## Product Change Notification - SYST-20NNTW458

Data Sheet - AT24CS01/02 - Complete Datasheet Document Revision

## I<sup>2</sup>C-Compatible (Two-Wire) Serial EEPROM with a Unique, Factory-Programmed 128-Bit Serial Number 1-Kbit (128 x 8), 2-Kbit (256 x 8)

Figure 4-1. Bus Timing

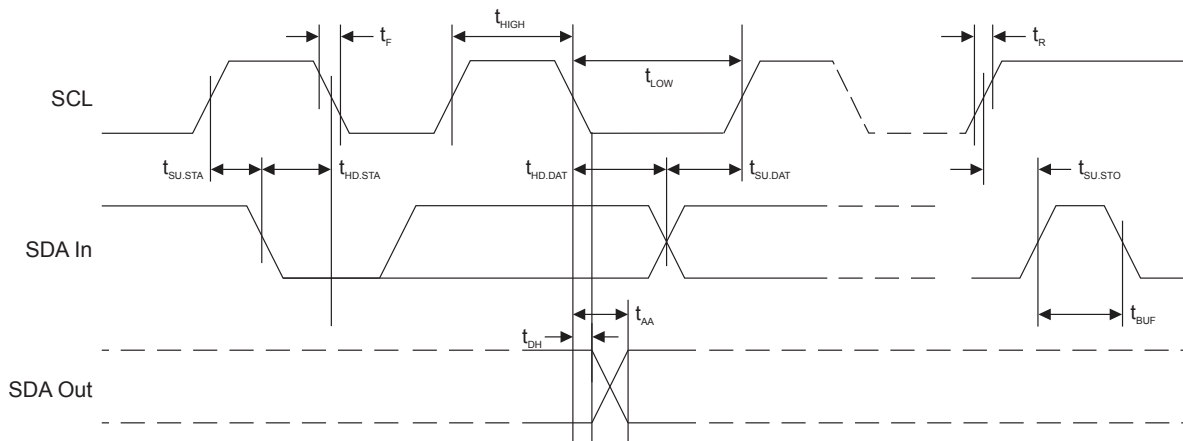
**Description of Change:** Updated to Microchip template. Microchip DS20006330 replaces Atmel document 8815. Corrected tLOW typo from 400 ns to 500 ns. Corrected tAA typo from 550 ns to 450 ns. Updated Part Marking Information. Updated the Software Reset section. Added ESD rating. Removed lead finish designation. Updated trace code format in package markings. Added a figure for System Configuration Using TwoWire Serial EEPROMs. Updated Block Diagram figure. Added POR recommendations section. Updated formatting to current template. Updated the SOIC, TSSOP, SOT23 and UDFN package drawings to Microchip format.

Figure 5-2. Software Reset

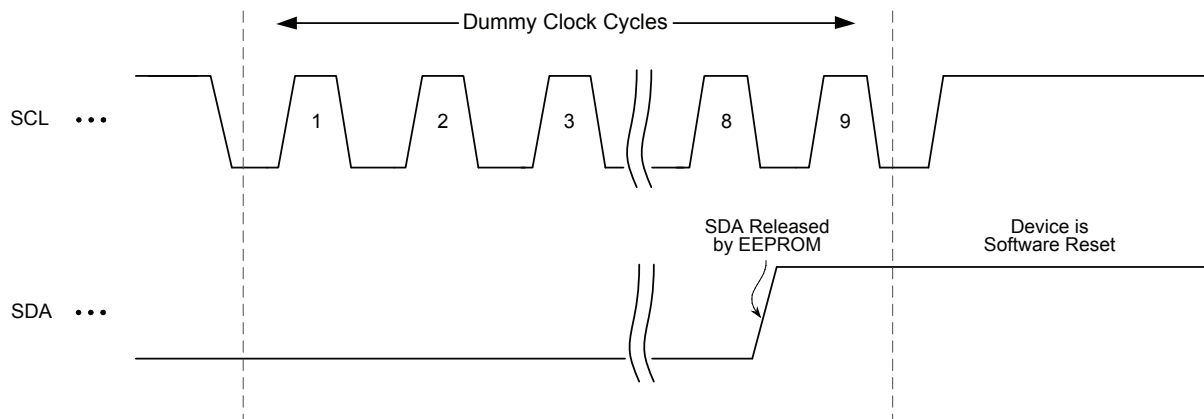
Updated to Microchip template. Microchip DS20006330 replaces Atmel document 8815. Corrected  $t_{LOW}$  typo from 400 ns to 500 ns. Corrected  $t_{AA}$  typo from 550 ns to 450 ns. Updated Part Marking Information. Updated the "Software Reset" section. Added ESD rating. Removed lead finish designation. Updated trace code format in package markings. Added a figure for "System Configuration Using Two-Wire Serial EEPROMs". Updated "Block Diagram" figure. Added POR recommendations section. Updated formatting to current template. Updated the SOIC, TSSOP, SOT23 and UDFN package drawings to Microchip format.
